## Product / Process Change Notification (PCN)

**PCN #:** PCN\_IndDPC\_20231221

**Affected Series:** WE-DPC; 7448844xxx, S17100063

Marking with  
Laser Marking

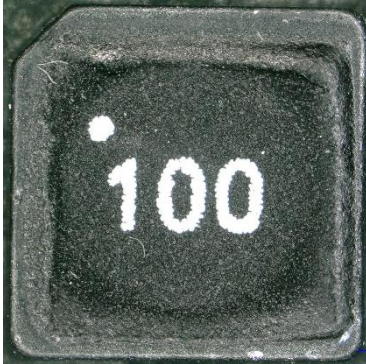
To increase the production capability, Würth Elektronik will implement a laser marking process.

All products with date code 2023-12-21 or later, will be affected by this change.

3.) Marking appearance:

Marking with  
Pad Printing

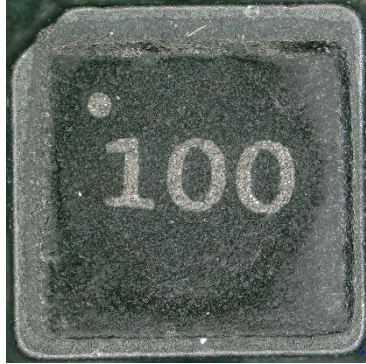
Current Method
